PALO VERDE NUCLEAR GENERATING STATION, UNIT NO. 3

AMENDMENT TO FACILITY OPERATING LICENSE

Amendment No. 9 License No. NPF-74

AMENDMENT NO. 9 TO FACILITY OPERATING LICENSE NO. NPF-74

FIGURE 3.1-1 ALLOWABLE MTC MODES 1 AND 2

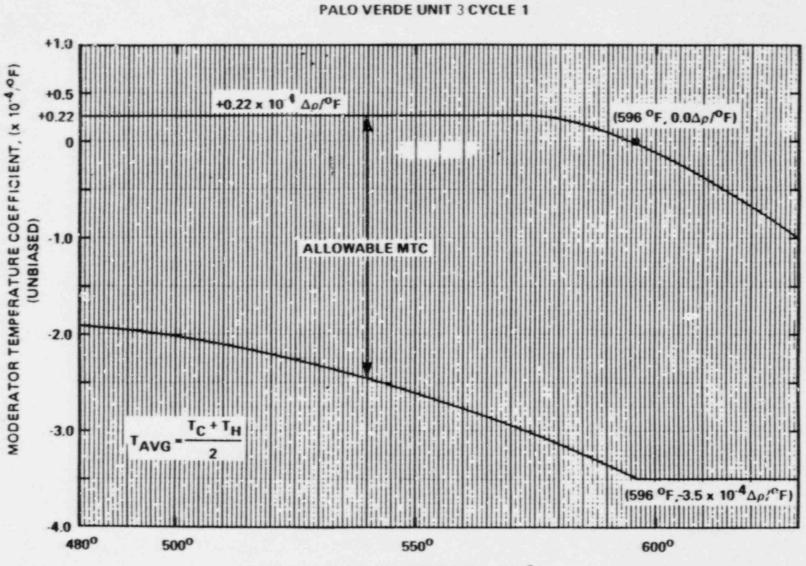
Replace the following page of the Appendix A Technical Specifications with the enclosed page. The revised page is identified by Amendment number and contains vertical lines indicating the area of change. Also to be replaced is the following overleaf page to the amended page.

Amendment Page	Overleaf Page
3/4 1-5	3/4 1-6
